ADDENDUM #1

10 July 2012

RE: Eli Whitney CTHS
Additions & Renovations Project
71 Jones Road
Hamden, CT 06514
Job Nos.: Department of Construction Services – BI-RT-837 / Antinozzi Associates - 04210

FROM: ANTINOZZI ASSOCIATES, P.C.

DRAWING TITLE: REVISED PARTIAL "B" WING - WEST ELEVATION (PARTIAL)

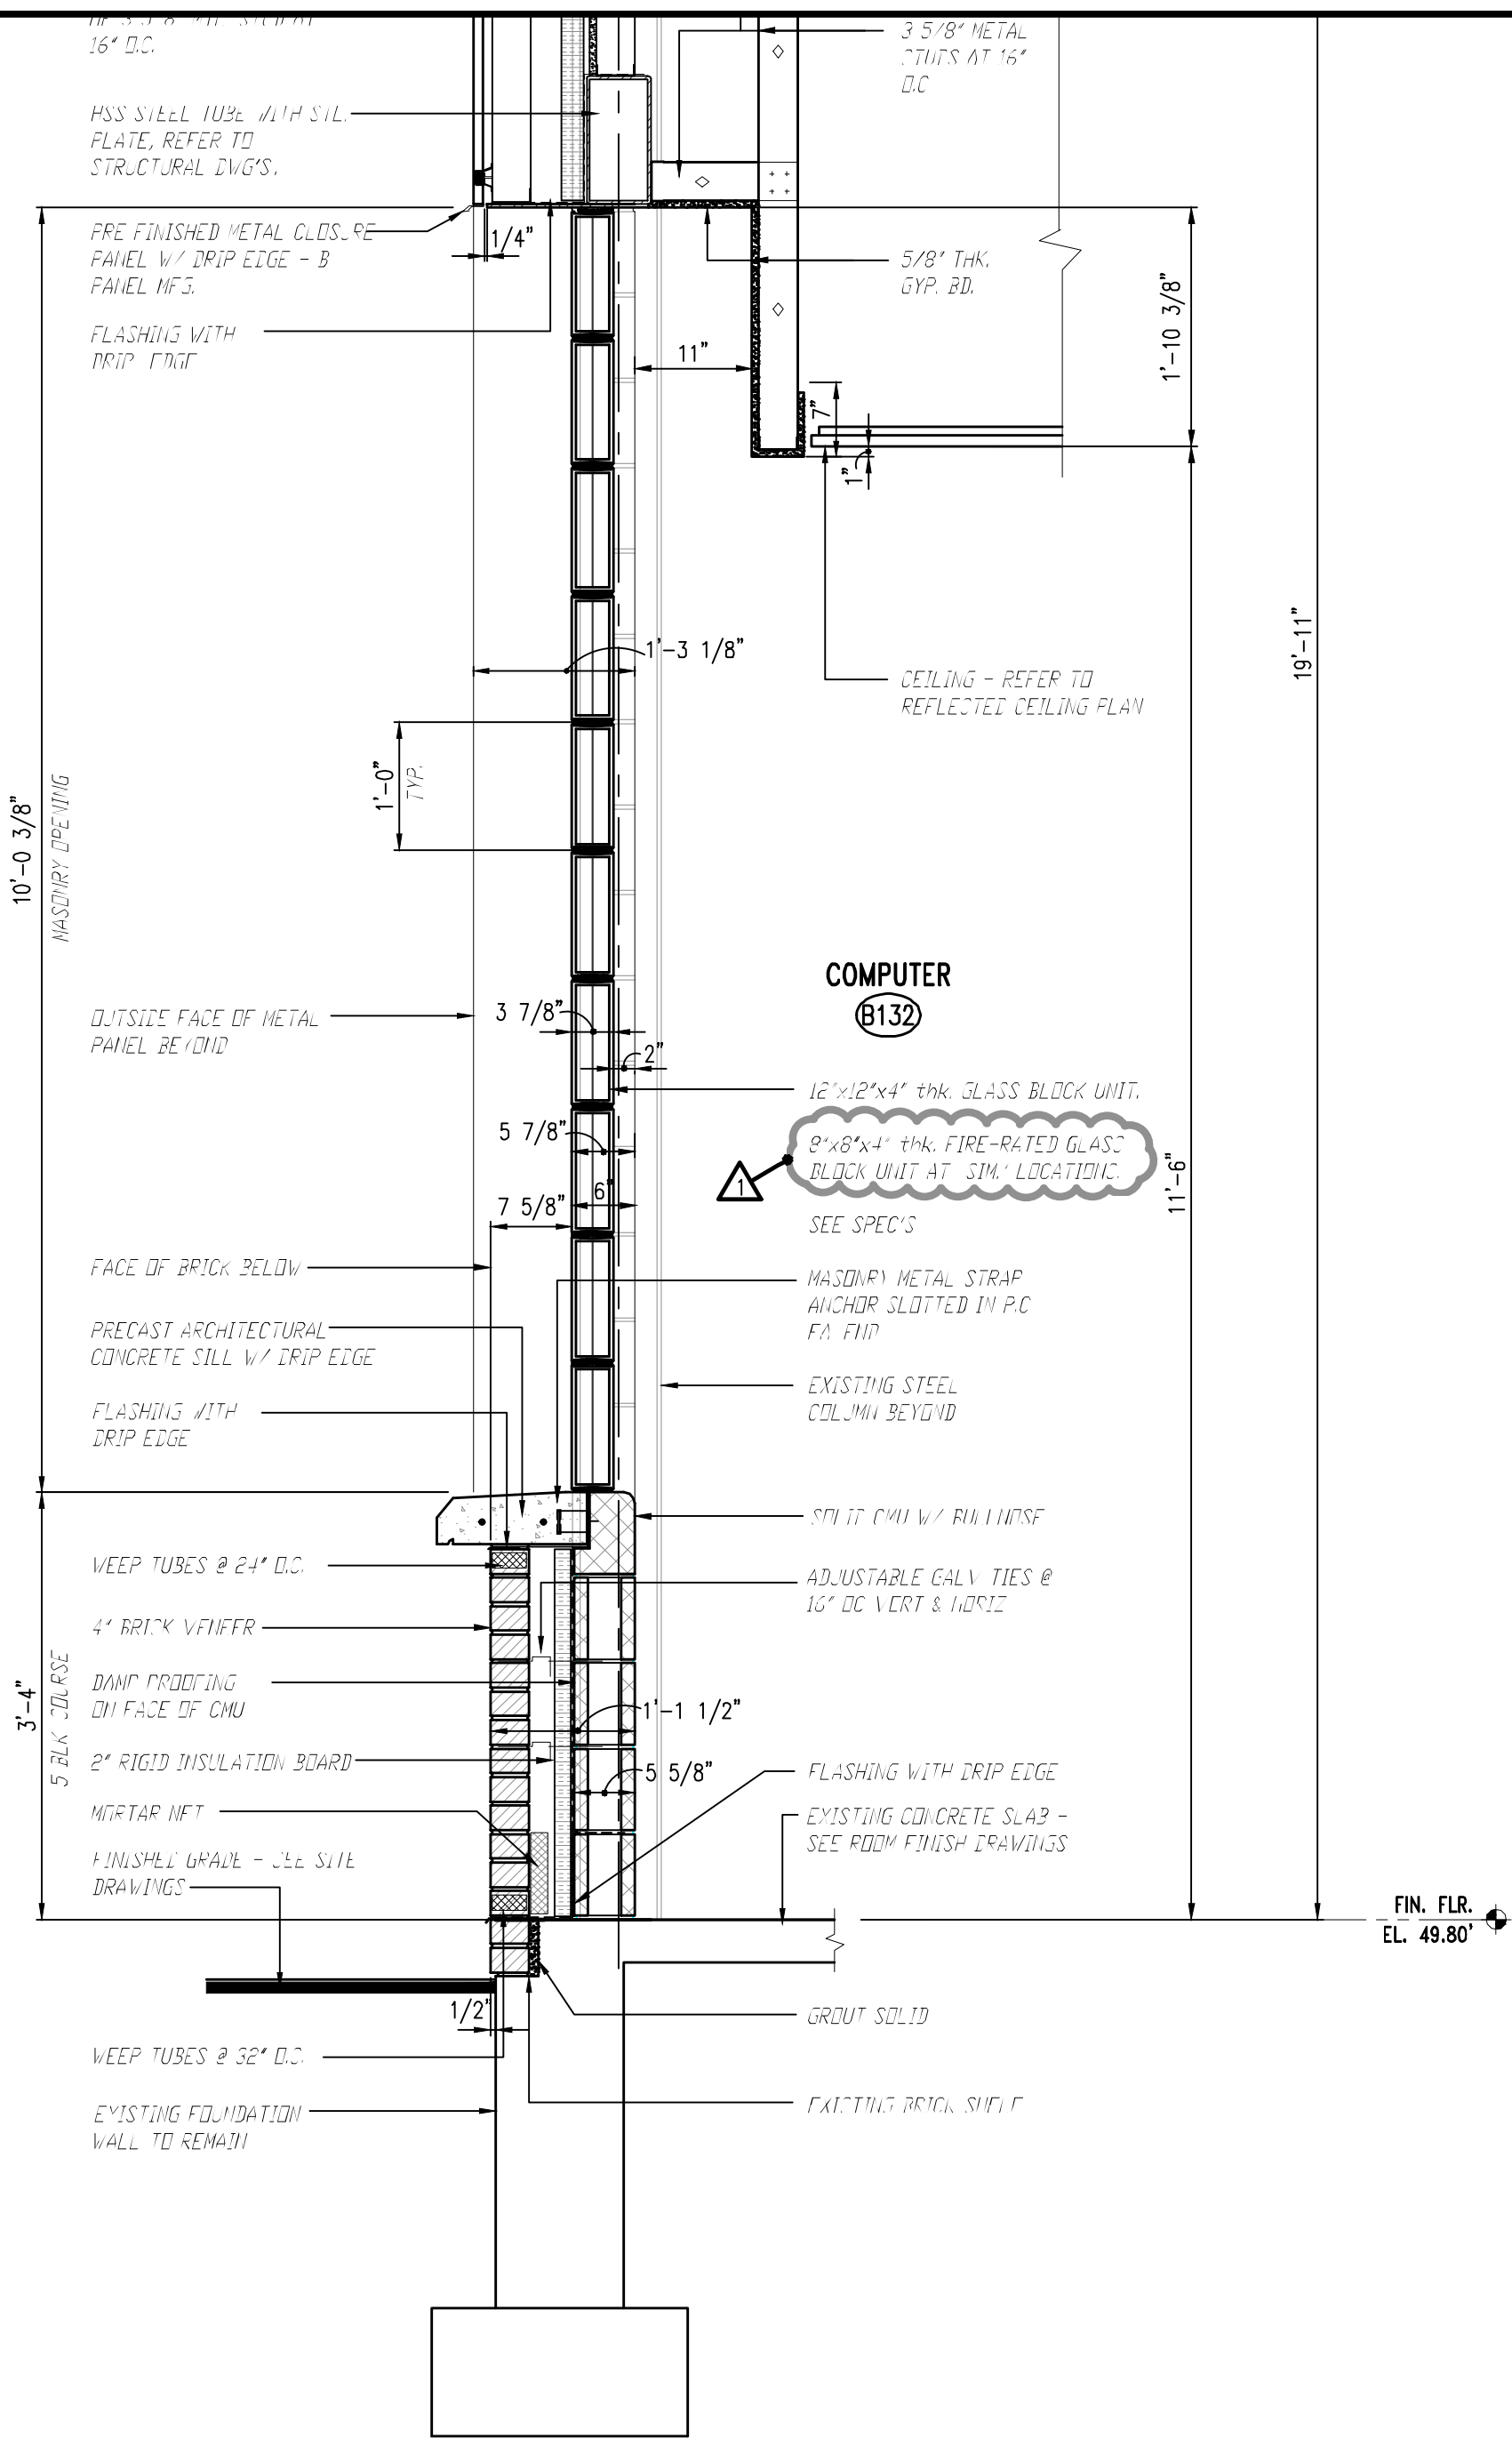
4) **Question:** *It is not possible to create a 5'x5' glass block panel with 8"(wide)x8"(tall)x4"(deep) nominal full blocks as indicated in detail 2a/A303 as 5' (60") is not evenly divisible by 8". Should the glass block panel noted to be 5'x5' specified to have the 8"x8" blocks be changed to 5'-4"x5'-4" or other dimensions to use full blocks? If the glass block panels shown to be 5'x5' were changed to 4'x4' or another common multiple of 8" and 12" then the windows could be approximately the same size with the use of either size block. Please clarify the documents as applicable. Note that the nominal sizes are approximate and the actual measured openings should have an additional 1/2" to 3/4" for the glass block to have proper movement as required.*

- a) **Question:** *Specification Section 042300, part 2, subsection 1.9 indicates that the specified glass block should be nominally 12"x12"x4" with a 45 minute fire rating with clarifications noted. Detail 2a/A-303 shows glass block panels which are indicated to have 8"x8" glass blocks with a one hour rating at two locations. Other elevations show 5'x5' panels and 10'x10' panels at other locations.*

- a) Drawing **A-303** – Exterior Elevations B-Building: Insert revisions to Detail 2A/A-303 as shown on Drawing SKA-04 - Revised Partial B-Wing - West Elevation (Partial)
- b) Drawing **A-102.1** – Area B1 Main Level Floor Plan: Insert revision as shown on Drawing SKA-03 - Revised Area B1 Main Level Plan (Partial)
- c) Drawing **A-513** – Wall Sections Wing B: Insert revisions to Details 2/A-513 as shown on Drawing SKA-05 - Revised Wall Section at B-Wing (Partial), and Detail 3/A-513 as shown on Drawing SKA-06 - Revised Wall Section at Wing B (Partial), and revisions to details A/A-513, B/A-513, C/A-513, & D/A-513 as shown on Drawing SKA-07 - Revised Head/Jamb/Sill Details.
- d) Drawing **A-920** – Window / Curtainwall Schedule: Insert the revisions as shown on Drawing SKA-08 - Revised Window Types (Partial).

ALL SCHEDULE - (NEW OPENINGS)

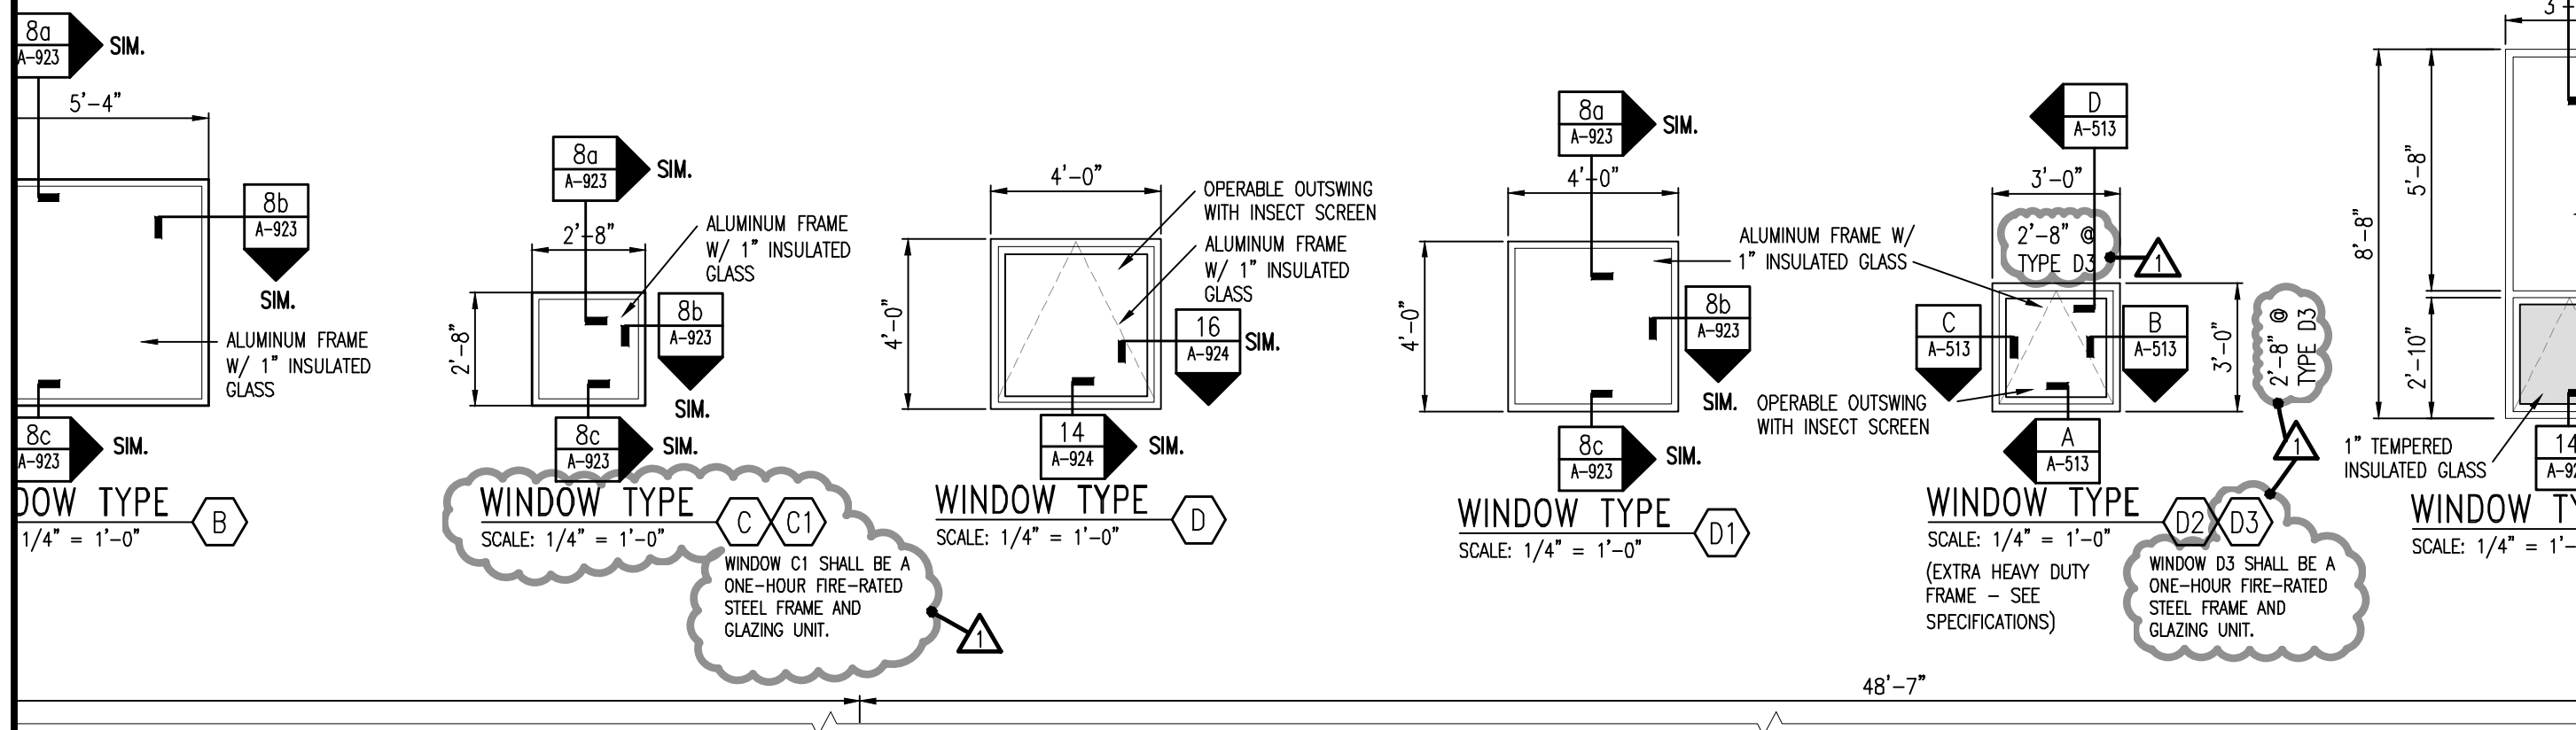
- 8) **A-920** – Window Curtain Wall Schedule
- a) **Question:** *Detail C1/A920 is for fire rated aluminum windows. What specification section should be used for these windows? Please provide a new specification or additional information if applicable. Thank you.* **Answer:** Fire rated windows where required are Steel Framed Windows and shall comply with Specification Section 08 51 19 – Steel Windows. Delete fire rated note at Window Type Detail C1/A-920, and insert the following in lieu thereof: “Window C1 shall be a steel framed one-hour fire rated frame and glazing unit.”

DRAWING TITLE:
REVISED AREA B2 UPPER LEVEL PLAN (PARTIAL)

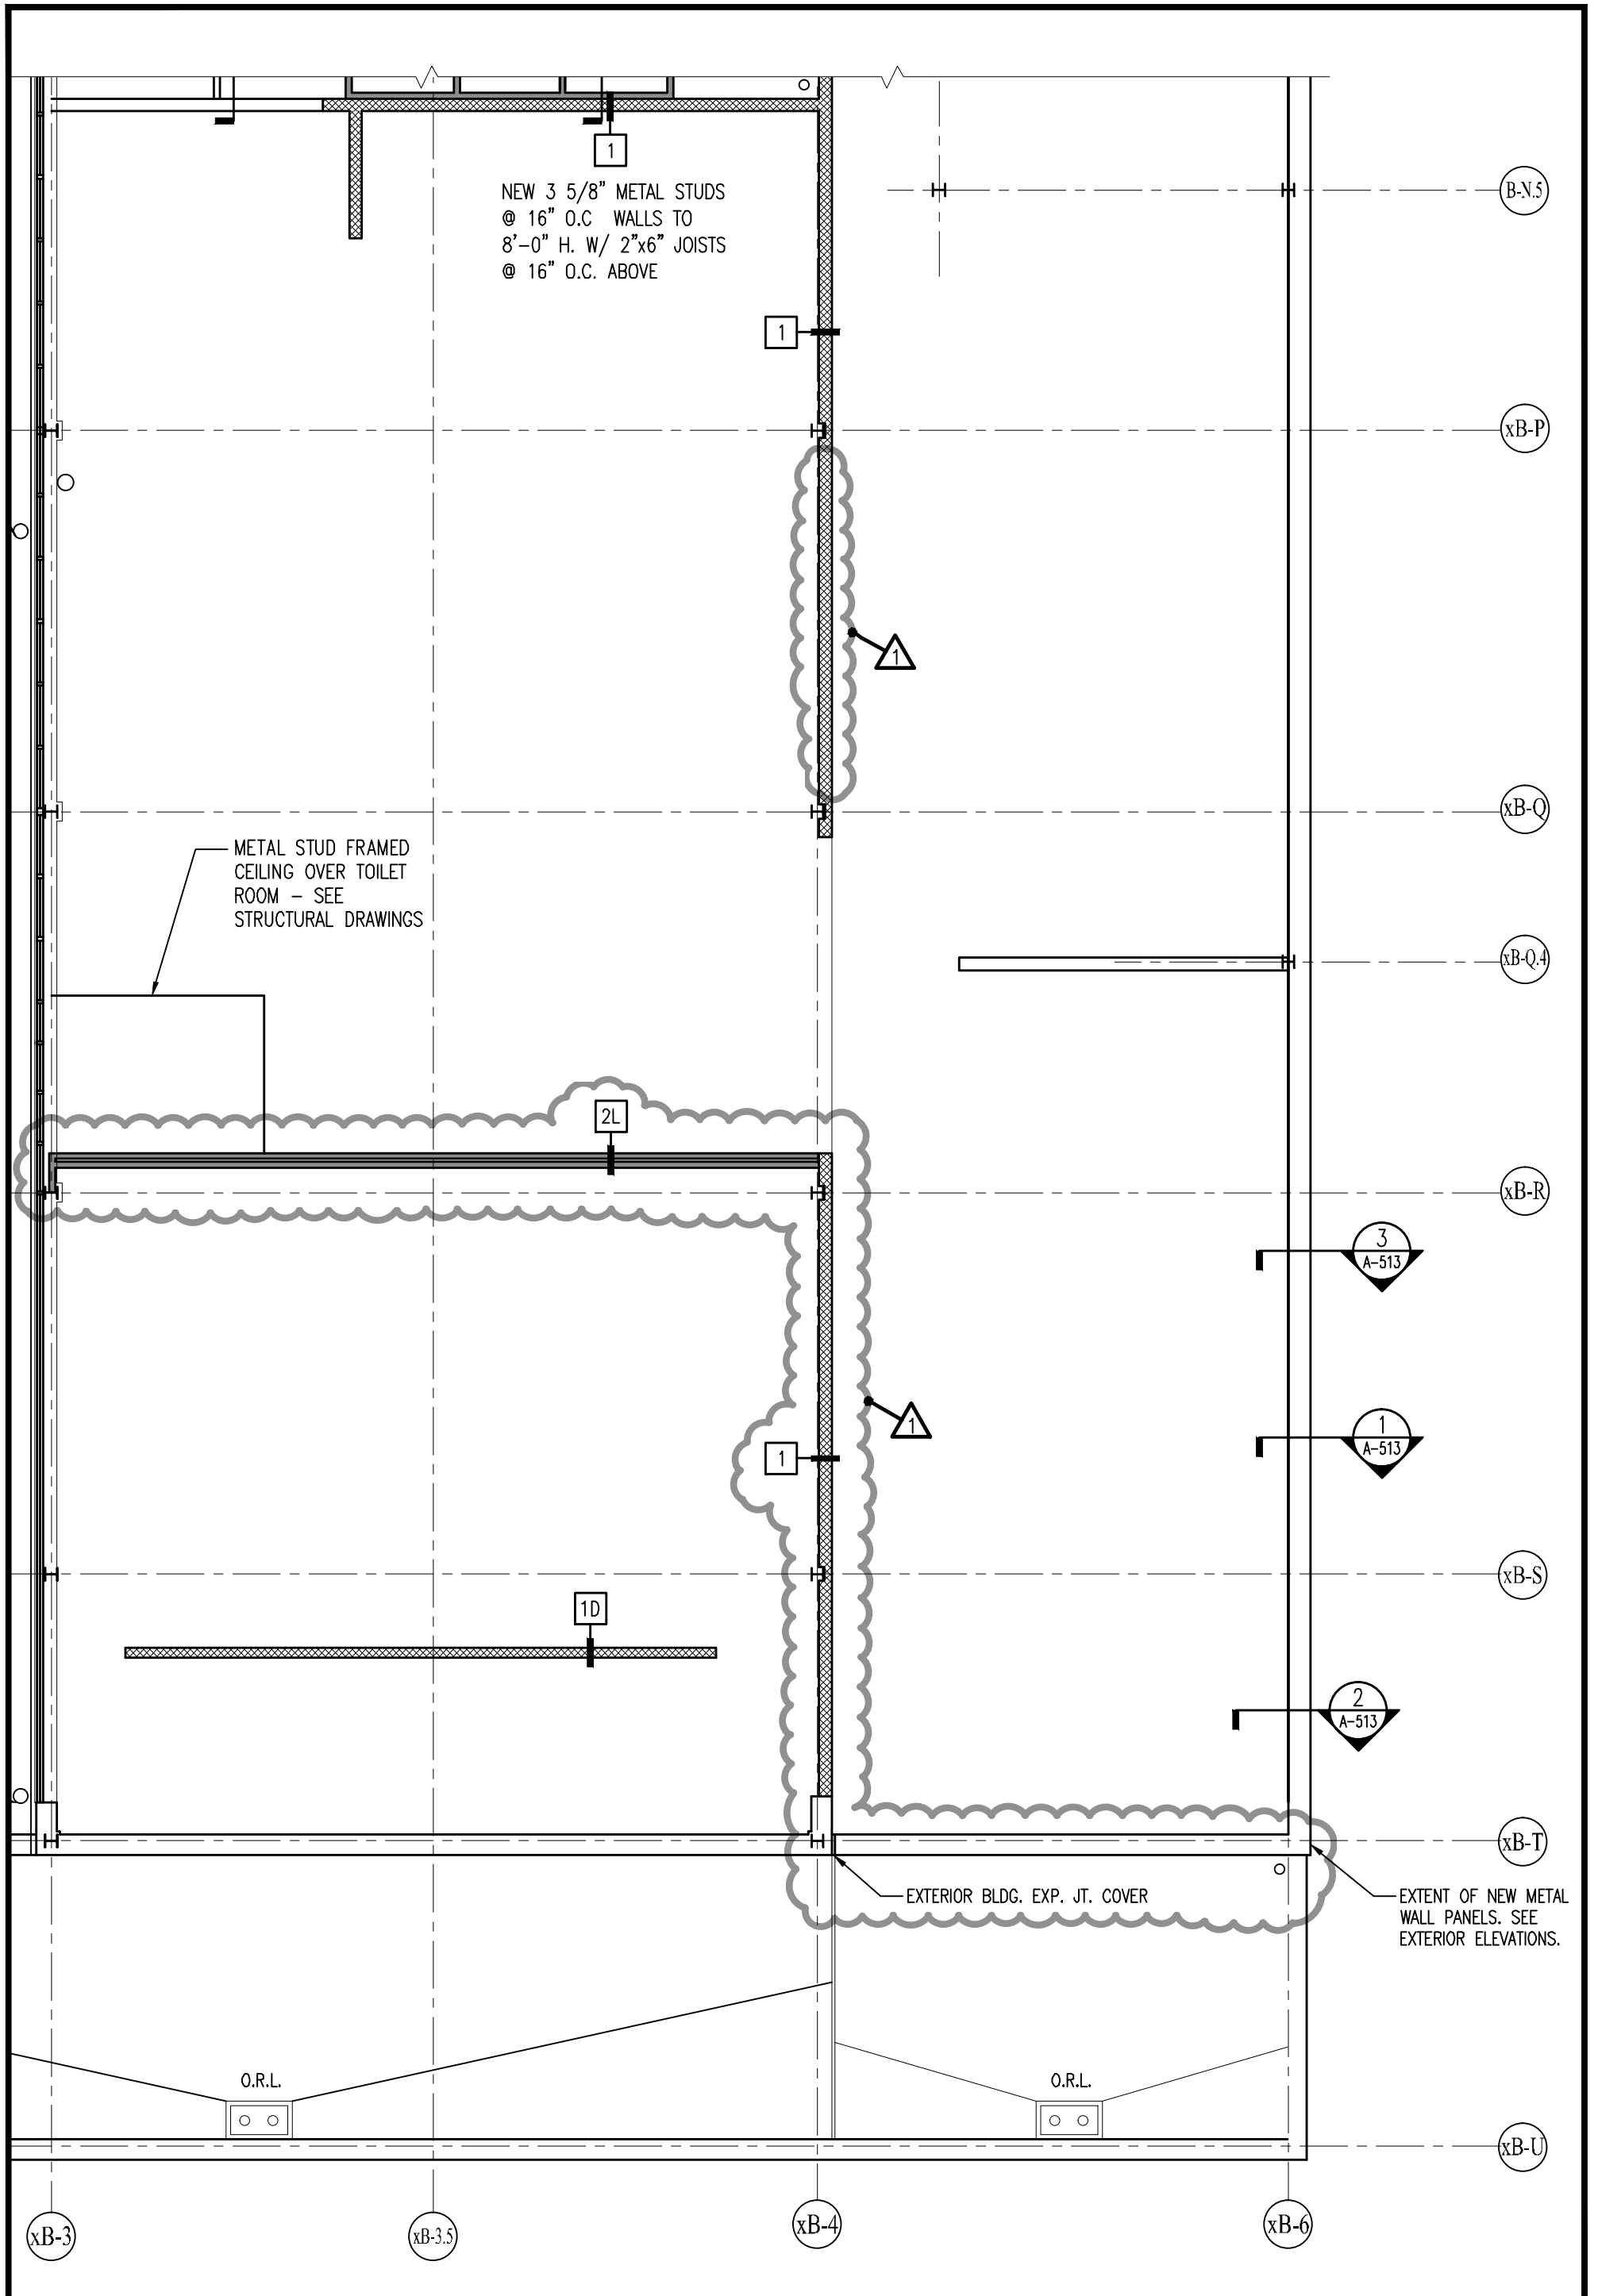
- a) **Question:** Refer to drawing A102.1. There is a wall on the xB-R line between xB-3 and xB-4 that is a gyp.board stud partition. The same wall on the upper level drawing A102.3 is CMU. The adjacent spaces are open to below so this wall carries full height up to the roof deck above. Please clarify whether the wall is CMU or drywall. **Answer** Insert edits as shown on SKA-09 – Revised Area B2 Upper Level Plan (Partial) for clarification.
